RECEIPT DATE: 12/9/16      **ONSITE SEWAGE DISPOSAL SYSTEM**      P 559870  
 APPROVAL DATE: 01/12/2017      **PERMIT: CONSTRUCTION**      A \_\_\_\_\_  
 PROPERTY ADDRESS: 12403 All-Daughter's Lane  
 SUBDIVISION: Orchard Estates      LOT: 1      TAX ID: 05-451051  
 CONTRACTOR: Hatfield's Equipment      EMAIL: ken@hatfieldsequipment.com  
 CONTRACTOR ADDRESS: P.O. Box 519, Annapolis Junction, MD 20701      PHONE: 301-490-4289

SEWAGE DISPOSAL SYSTEM SPECIFICATIONS WORKSHEET

SITE PLAN FOR BAT INSTALLATION  
ORCHARD ESTATES  
LOT 1 (12403 All Daughters Lane)  
PLAT No. 19876-19877  
ELECTION DISTRICT No. 5  
HOWARD COUNTY, MARYLAND

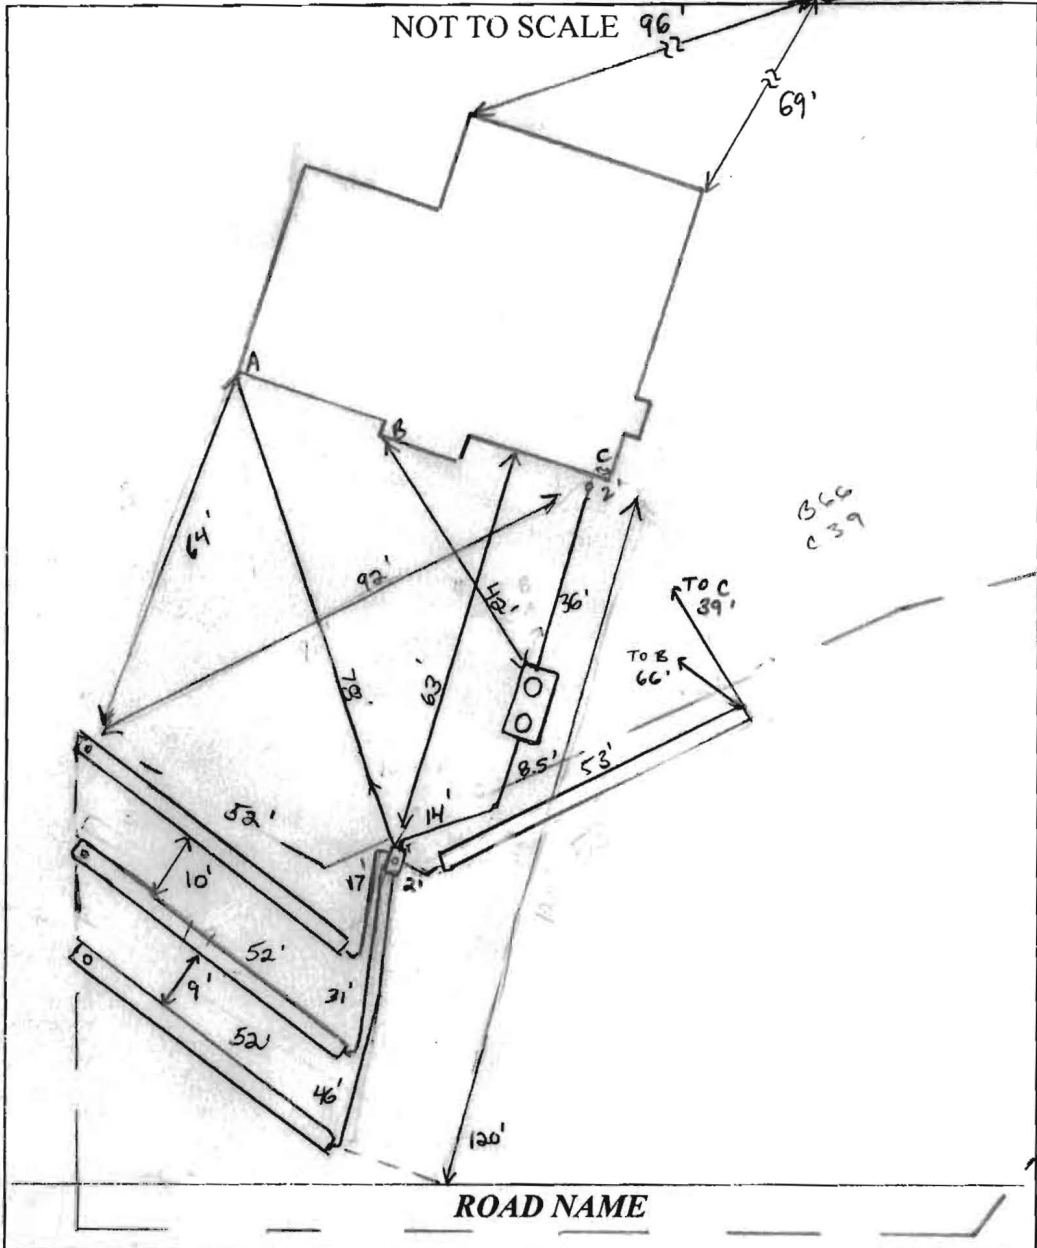
NOTES: *Due to limited soils per OH pros (see per note), Bottom area only was achieved on lowest trench. Additional trench to be installed west of Dbox along upper portion of SDA. Trench specs = 14.52', 3' wide, Inlet 8-8.5', Bottom 5-5.5'. (Knew)*

12/23/16 On site with Hatfield's for layout. All tank and SDA stakes present. Shot contour and laid out 3x53' trenches. (SC) 1/9/17 Met Hatfield's on site. Shot contour and laid out 1x52' trench on contour. Set 5' bottom depth at end of trench - start will be 4-5' deeper b/c of fill near D-box. (SC) 1/10/17 Reshot contour, laid out 1x52' trench on upper part of SDA - area is flat, keep trench in upper vs. lower SDA. (SC)

12/27/16 House connection made. Tank + D-box installed. Hatfield's digging T3, 3' wide, 2.5' to stone. Using laser to check depths. Soil has high wage clay to 5'. (SC)  
 12/27/16 T3 complete + left open at ends, Hatfield's digging T2. Soil looks better, good soil starting around 3'. On site while Hatfield's finished T2. Layout + install 1x53' trench to E of existing trenches to make up for clay to 5' on T3. (SC)  
 12/28/16 Upper trench completed. Soil ok @ 3.5'. Will need another trench contour shot by contractor for possible trench location. OK to cover all work. Di 500 leveled. (KIP) (SC) 01/12/17 Measured radial trench. Inspect speed level. (P)

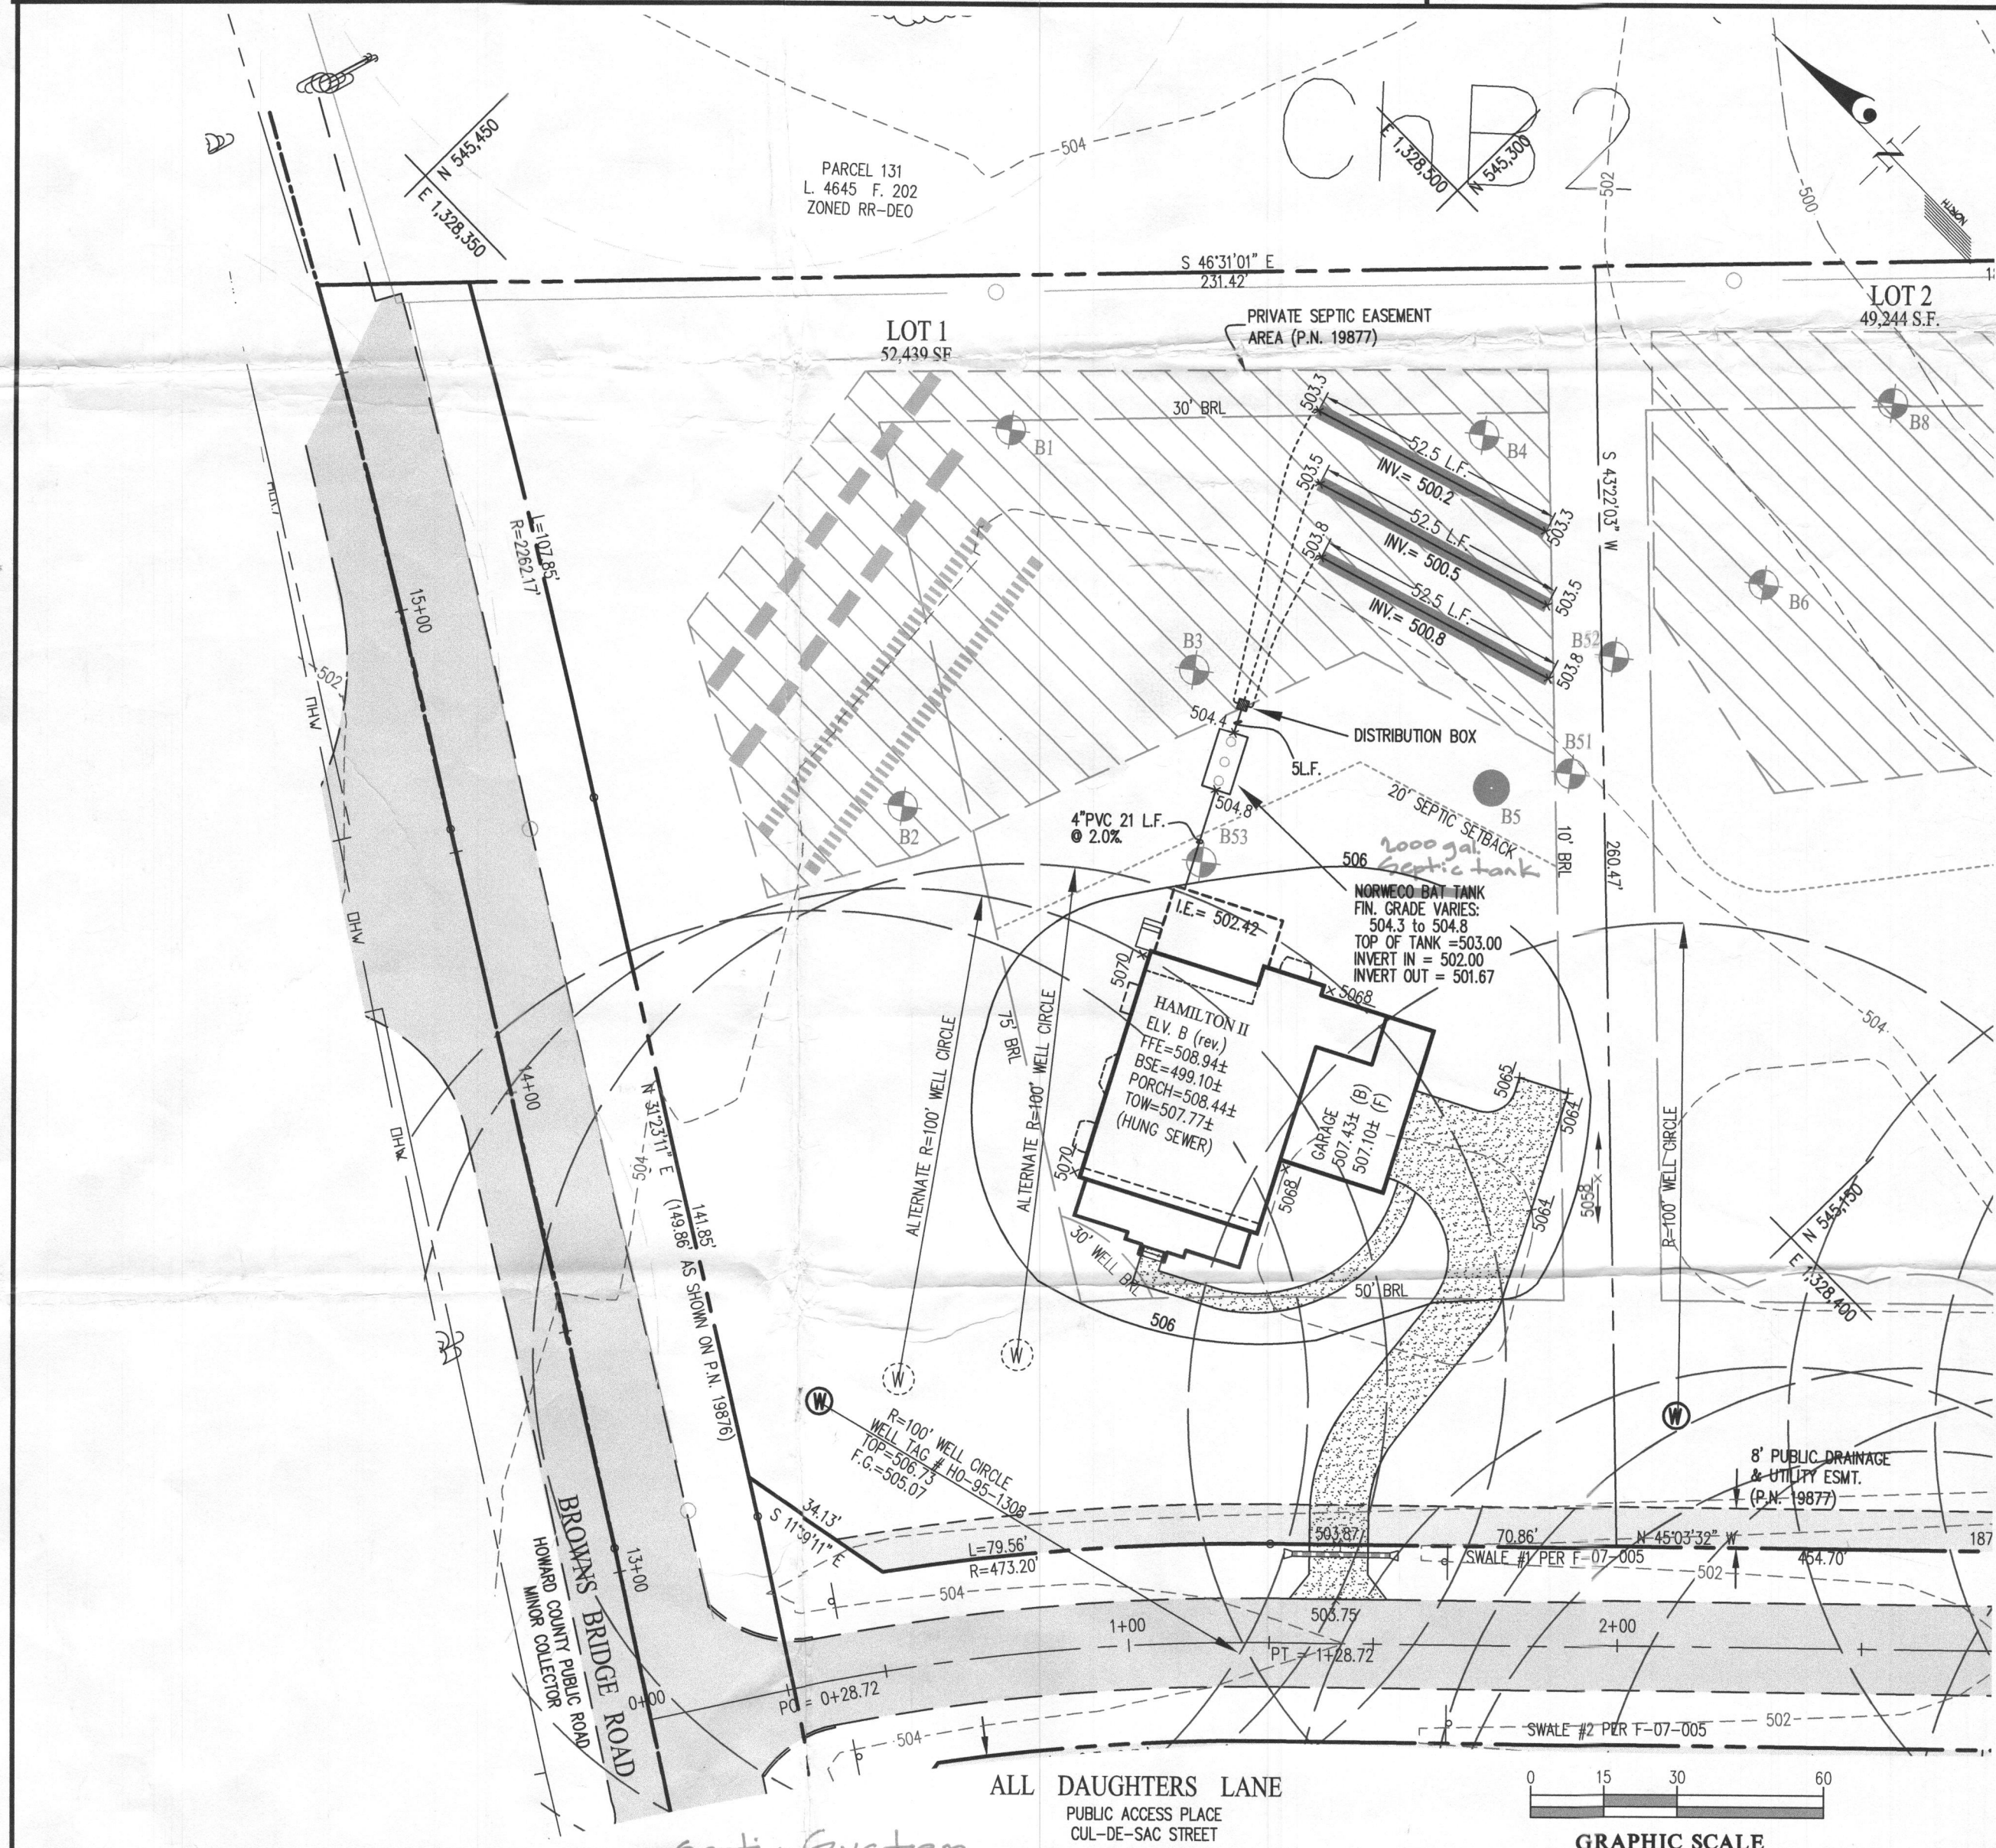
I was out there for the final trench install on 12/28. During the inspection, I noticed the soils we encountered on the lowest trench was a dense clayey soil in the upper 4.5'. The middle and upper trench showed improvement in the upper soil horizons at 3.5' to 5' which started to reflect the 2004 percolation tests. Given the trench spec's that was installed currently, this only gives us bottom area only on the lower trench and aprx. 2' of useable sidewall (effective reduction of linear feet) of trench. We need to make up at least 45' of trench (or another 52' trench to keep equal length trenches) keeping same spec's as installed (i.e. 3'wide, inlet 3 – 3.5', bottom 5-5.5'). We should be able to come off the distribution box and run 1x52' trench running west along the upper part of the SDA. Let me know if you have questions on this.
